PLANNING COMMISSION AGENDA

Monday – July 23, 2007

DR 07-05 – 1st Student Bus Facility – The applicant requests approval to construct a bus barn facility on a 4.87 acre vacant lot located on the North side of SE Township, west of the Molalla Forest Road. The facility would consist of a 7,700 square foot building to house the drivers dispatch area, administration offices and a bus maintenance facility. **Page 47**

- STAFF REPORT -

tabbles®
EXHIBIT
#3

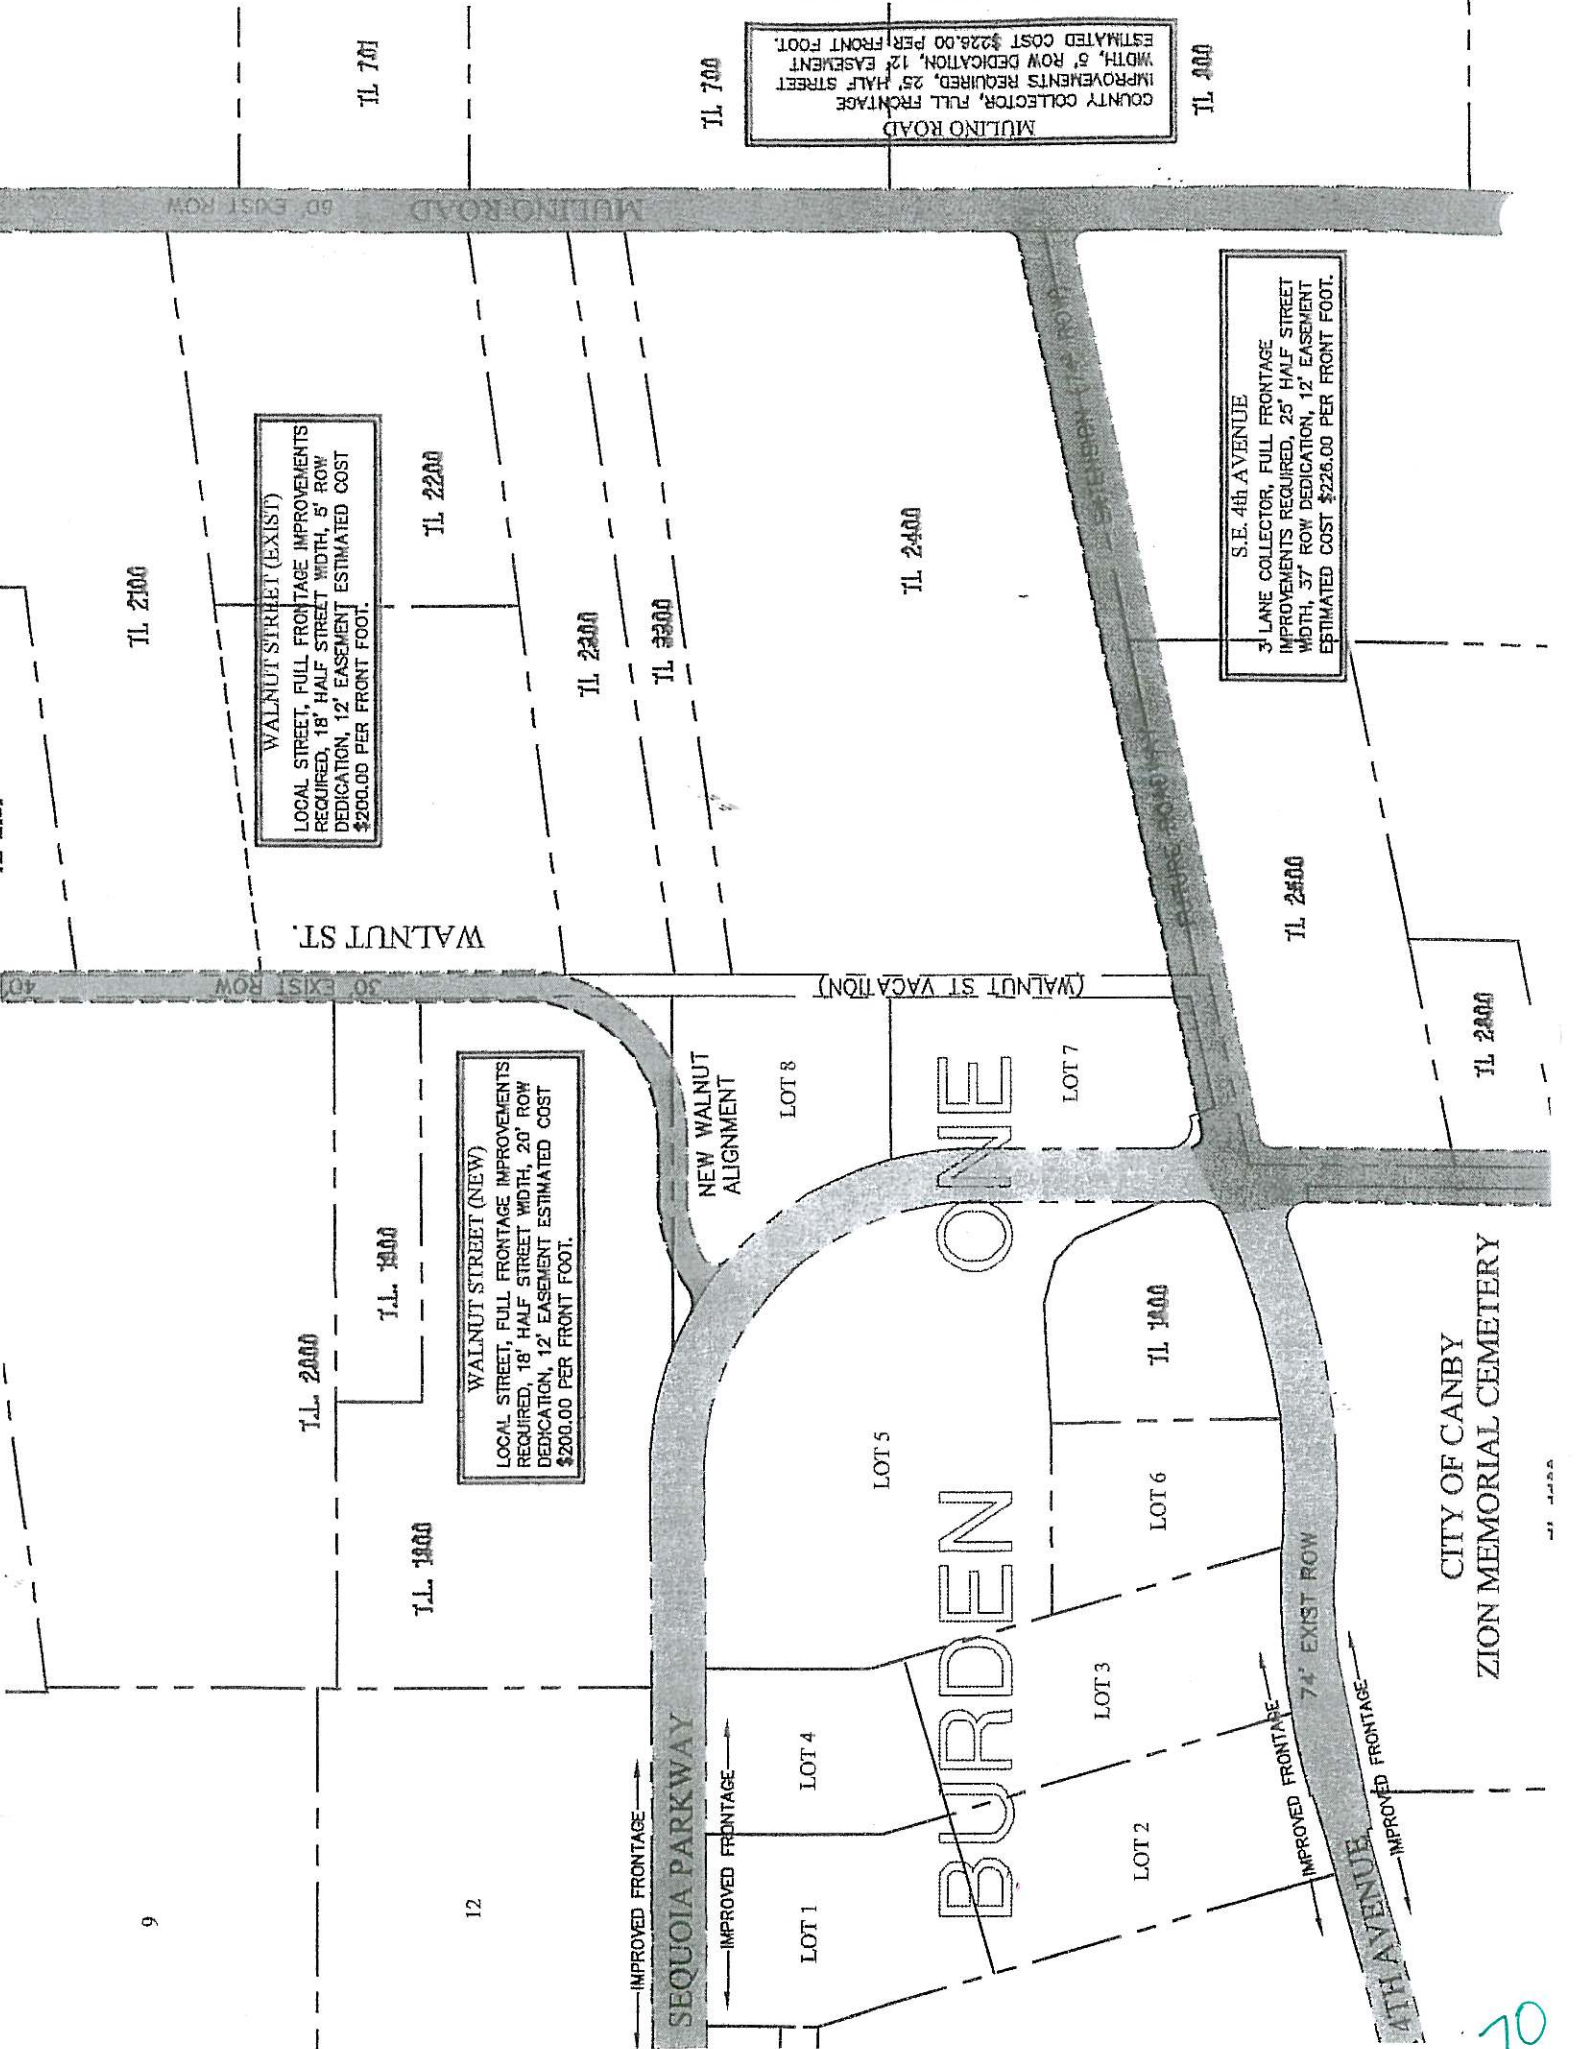
S. Walnut Street is unimproved and cannot handle added industrial traffic due to substandard pavement depth and width. The City has been working with property owners to develop a new alignment for S. Walnut Street, as shown in Exhibit 3. This alignment would facilitate access to Sequoia and eliminate what we see as an unnecessary section of roadway on Walnut. However, the new alignment is not contained in our Transportation System Plan and the City lacks authority to require its installation. The City has been encouraging property owners to voluntarily adopt the alignment (we believe it uses less land and will cost development less money), but that has not happened to date. Therefore, we propose a condition of approval (13) that requires Walnut to be fully improved either in its current alignment or in an alternative alignment approved by the City upon development of Lot 5. No driveways are proposed on S. Walnut Street at this time. Any development that adds traffic to Walnut Street will also require an adequate connection to arterial and collector streets, as required by condition 12.

WALNUT STREET (EXIST'G)
 LOCAL STREET, FULL FRONTAGE IMPROVEMENTS
 REQUIRED, 18' HALF STREET WIDTH, 5' ROW
 DEDICATION, 12' EASEMENT ESTIMATED COST
 \$200.00 PER FRONT FOOT.

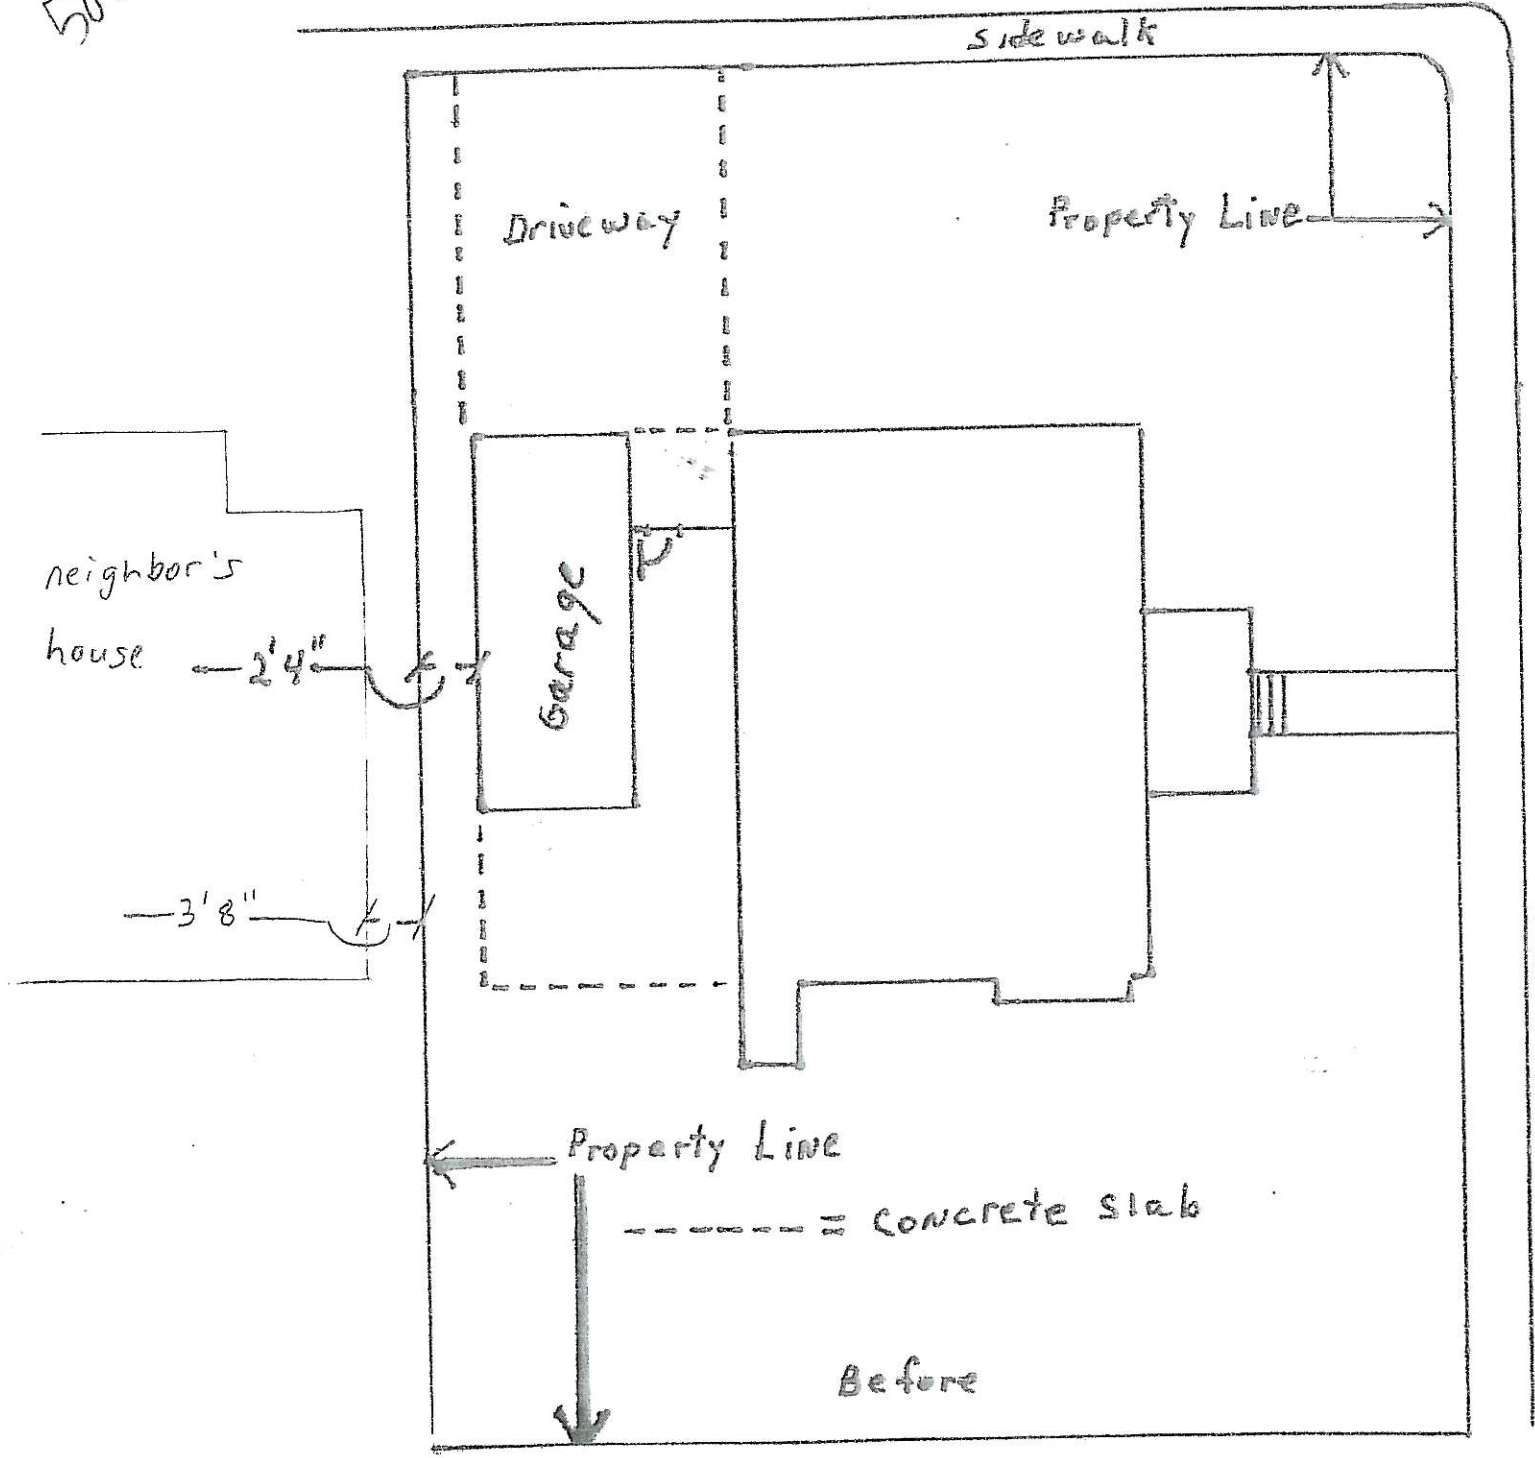
I have received the attached drawings for your proposed garage addition. The Fire District reviews the site plan and elevations, and applies the fire code specific to fire flow and access. The Fire District has no objections to your proposed variance, however, we strongly suggest "Class A" siding (Non-combustible) and enclosed eave soffets due to the distance between the garage and the neighboring home.
